Subject: UTS and UTG dust cap design change (for plugs only)

UTS610DCG - UTS612DCG - UTS614DCG

UTG610DC - UTG612DC - UTG614DC - UTG616DC

UTG610DCG - UTG612DCG - UTG614DCG - UTG616DCG

UTG plug cap, sizes from 10 to 16:

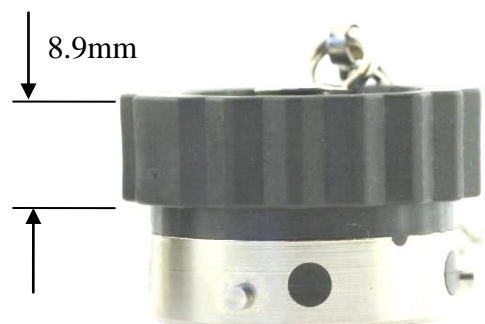
UTG & UTS cap flanges have been enlarged to ease the use in the field. Only sizes 10, 12, 14, 16 have been modified, other sizes already offered sufficient grip even when wearing gloves
